## SURREY COUNTY COUNCIL

**SUBJECT:** LONDON ROAD GUILDFORD ACTIVE TRAVEL SCHEME – INDEPENDENT TECHNICAL ASSESSMENT OF SECTION 1 FOR CONSIDERATION TO PROCEED.

Annex 1 – ARUP A3100 Burpham to Boxgrove Roundabout Technical Review

Table 1: Dimensions of London Road adjacent to Windy Cottage looking 'southbound' i.e., towards Guildford

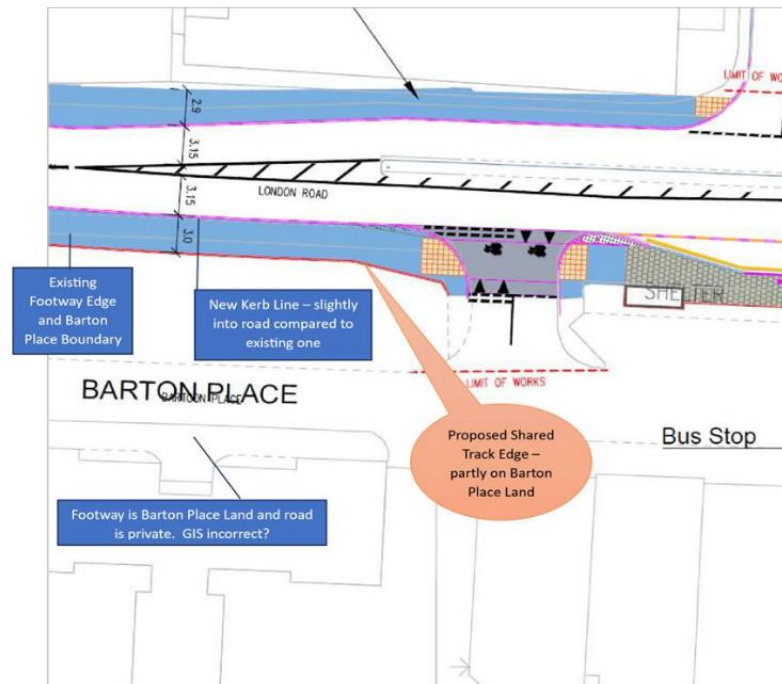
Watching bus and lorry traffic it is clear that with the current road width, particularly southbound, maintaining a course such that the wing mirrors between the cycle lane and the 'centre' line leaves minimal clearance on the straight parts of the road and is physically impossible on bends. Most vehicles cross both lines when negotiating the bend approaching the first Abbotswood junction. Even northbound there is very little clearance.
